AGENDA
BIRMINGHAM DESIGN REVIEW BOARD
WEDNESDAY MARCH 1, 2023
BIRMINGHAM CITY HALL, 151 MARTIN ST, COMMISSION ROOM 205, BIRMINGHAM MI *
******* 7:15 PM*******

DATE: March 1, 2023
TO: Design Review Board
FROM: Nicholas Dupuis, Planning Director
SUBJECT: 185 Oakland – Design Review

185 OAKLAND OFFICE RENOVATION

DATE: March 1, 2023
TO: Design Review Board
FROM: Nicholas Dupuis, Planning Director
SUBJECT: 33680 Woodward – Petrucci Studio – Design Review

RENDERED FRONT ELEVATION

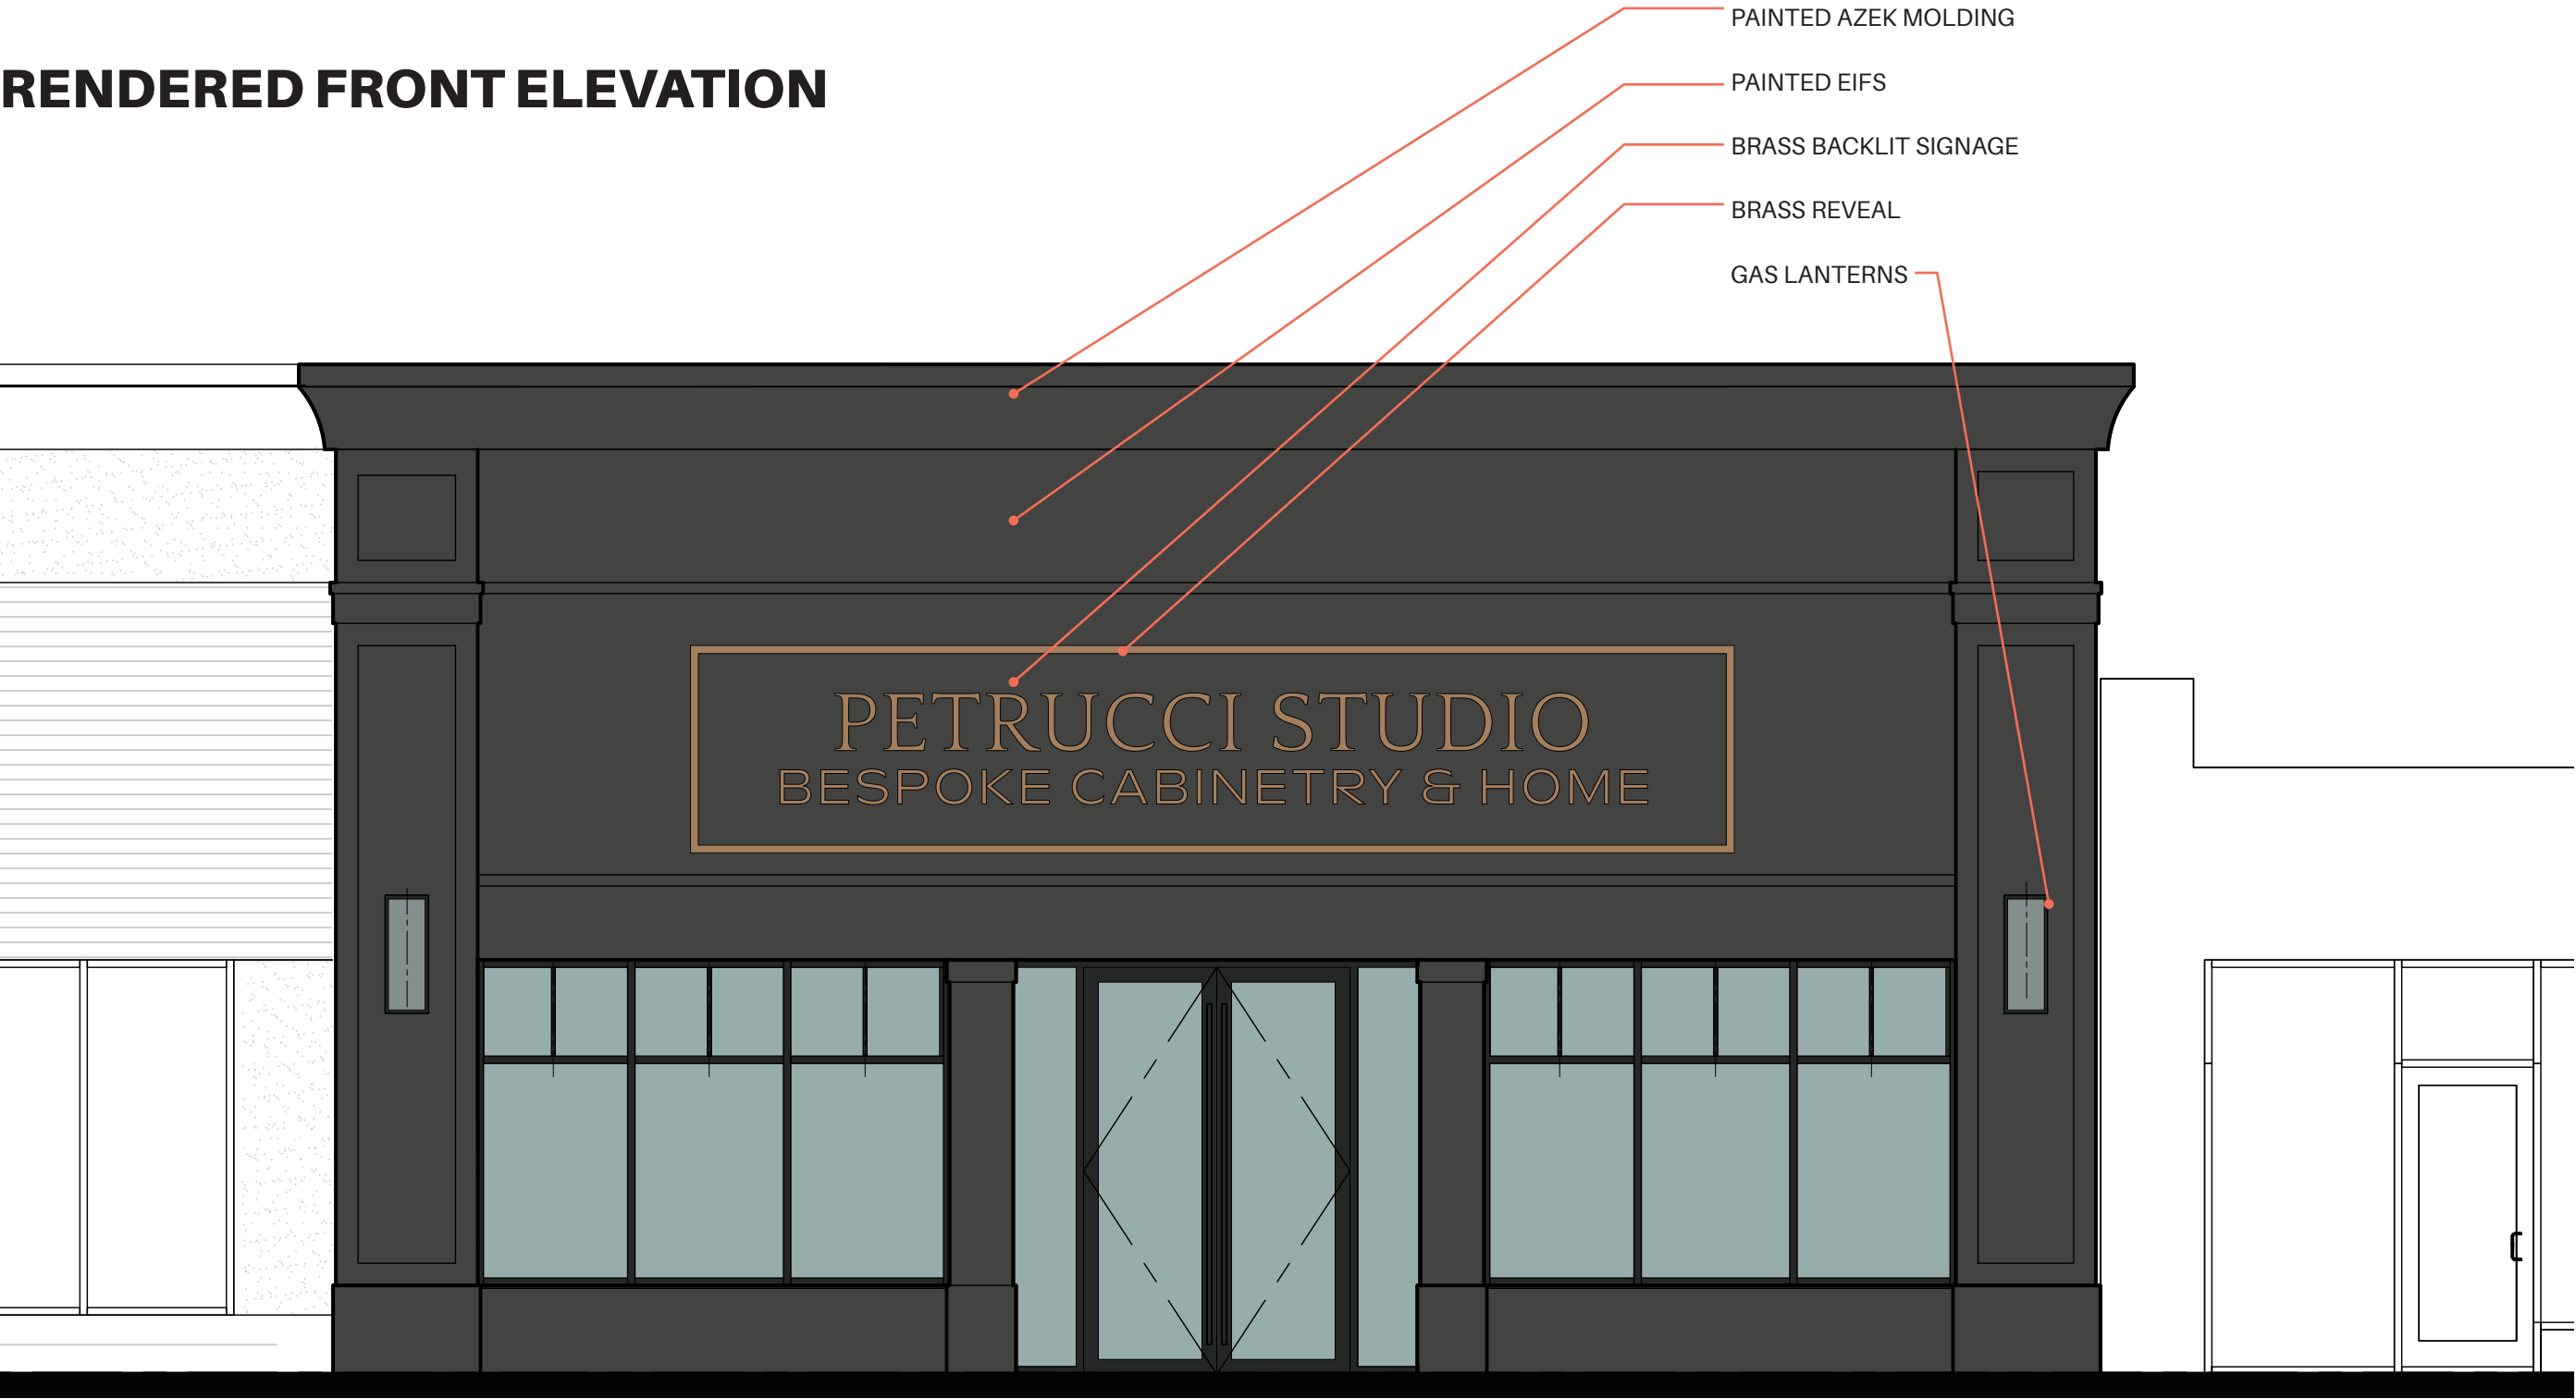
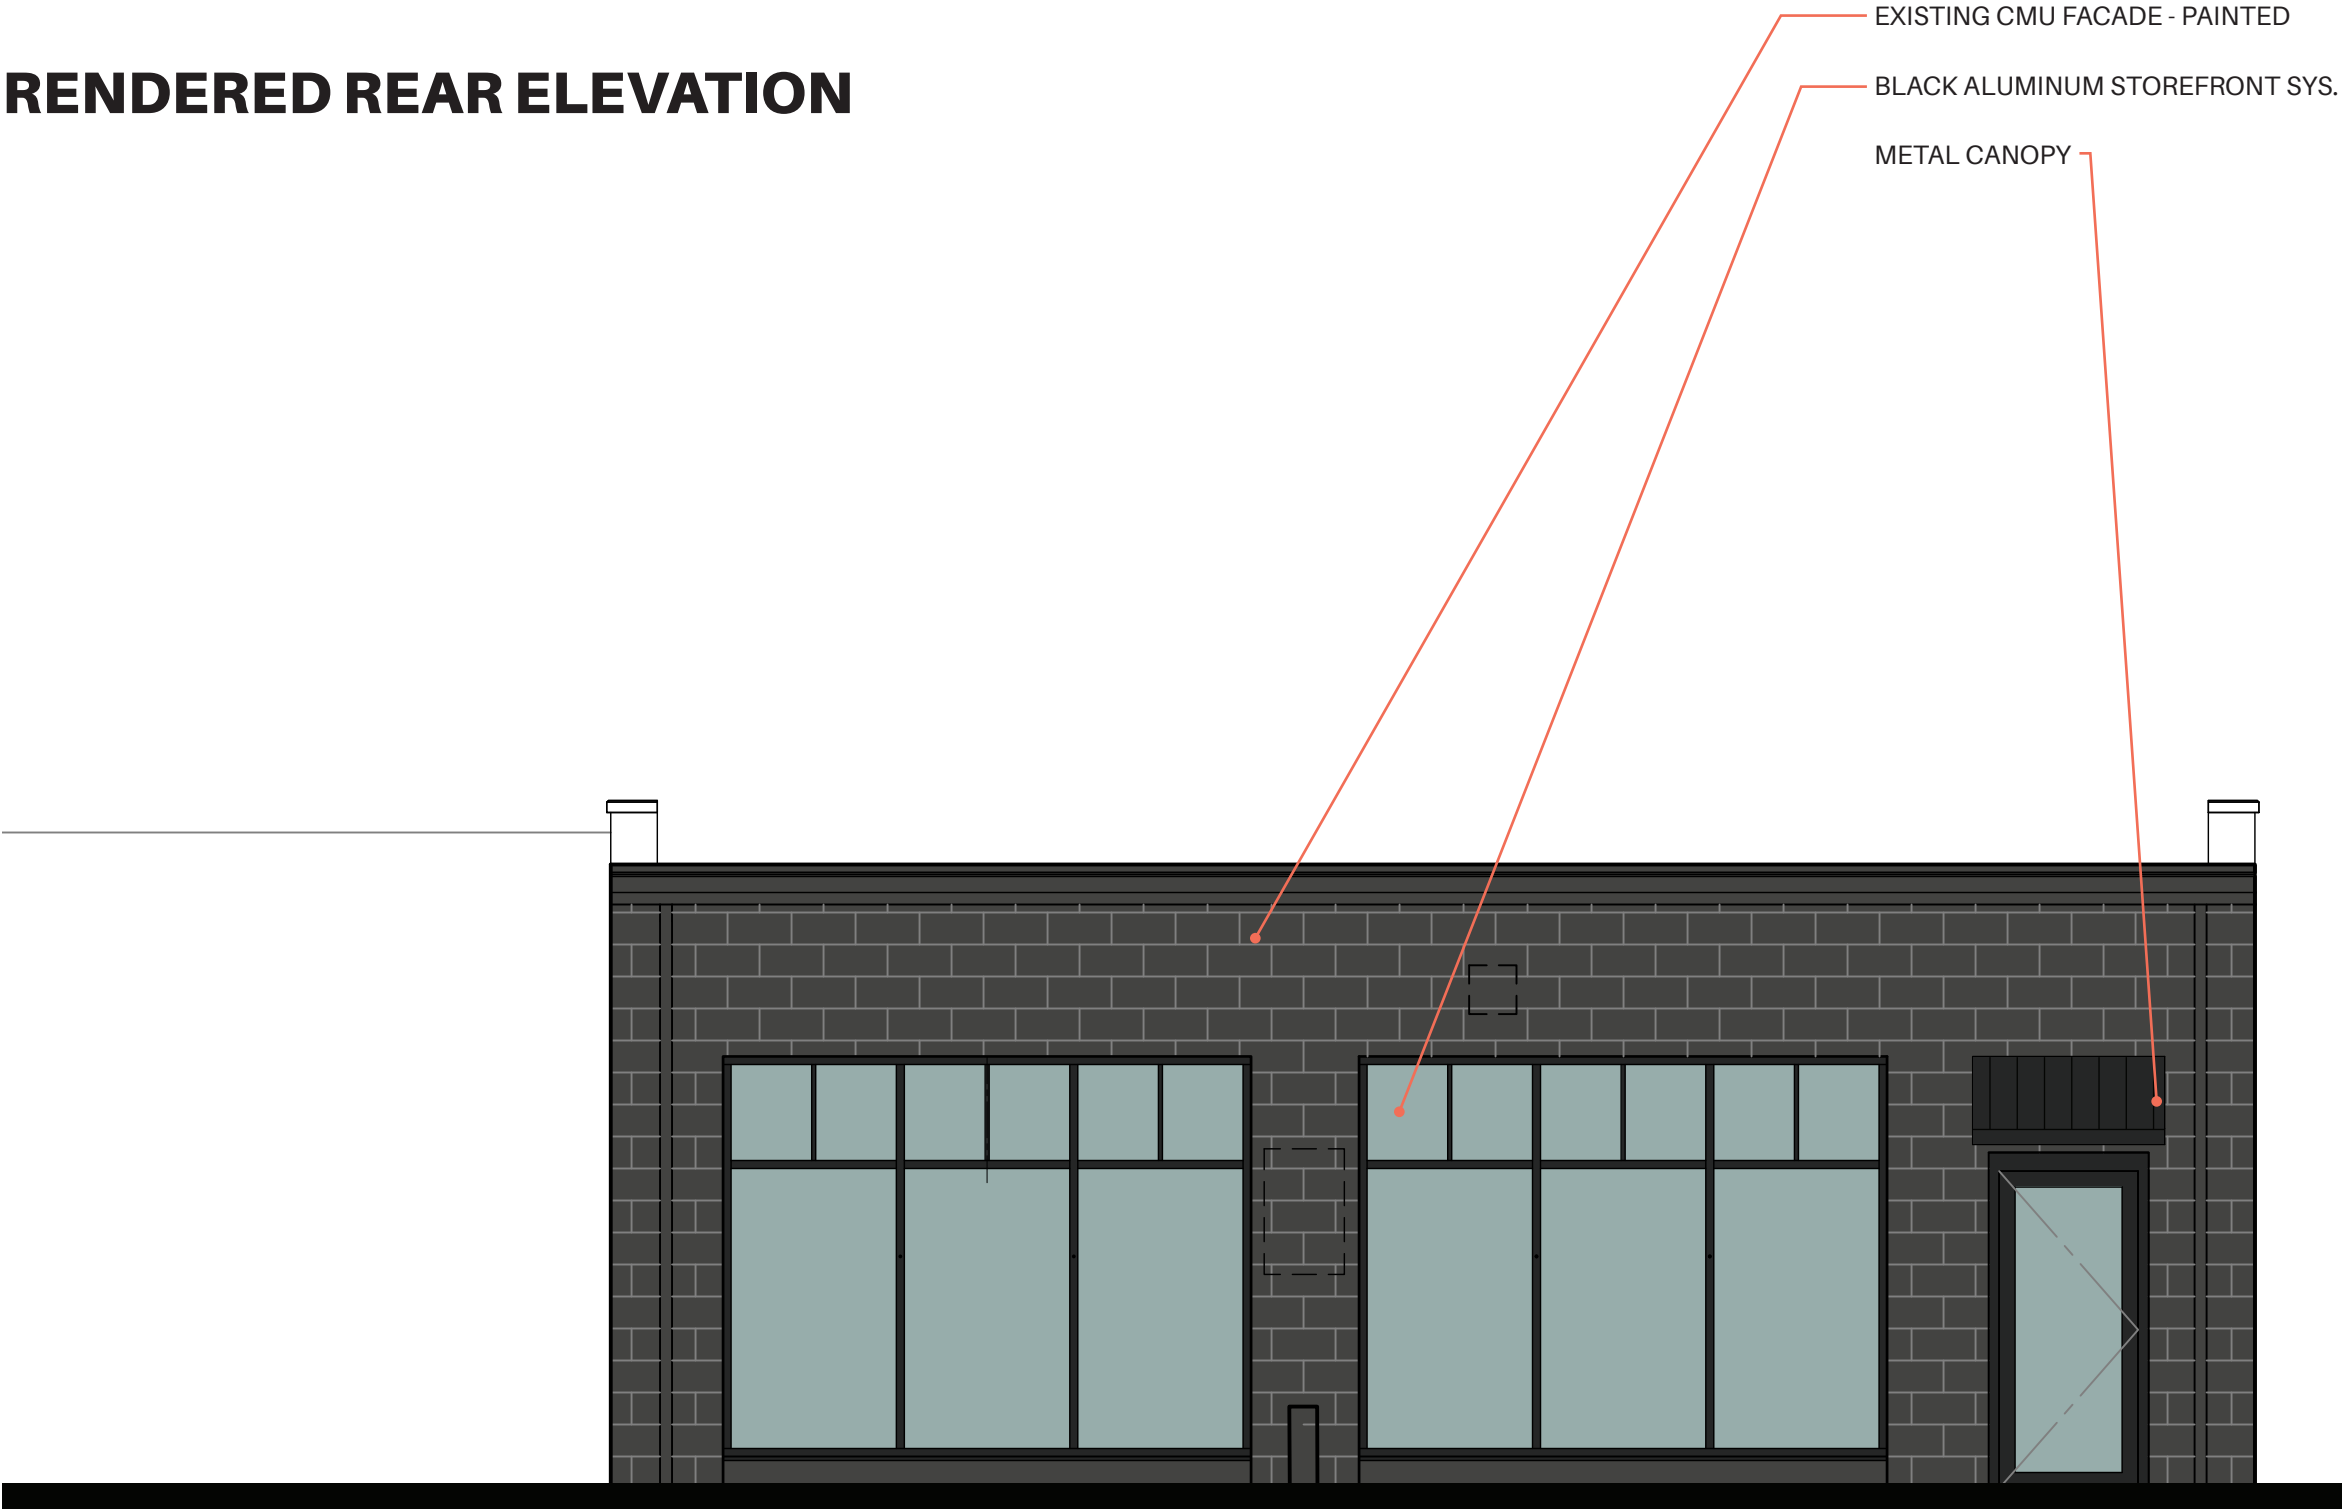
As a note, the applicant has submitted an elevation drawing in an overall site/design plan package, but also additional color rendered elevations in a supplementary document. There is at least one discrepancy that must be clarified in regards to the rear entry awning. One set of drawings calls it out as a fabric awning, while the other describes it as a metal awning. **The applicant must submit revised site/design plans with consistent material notes throughout.**
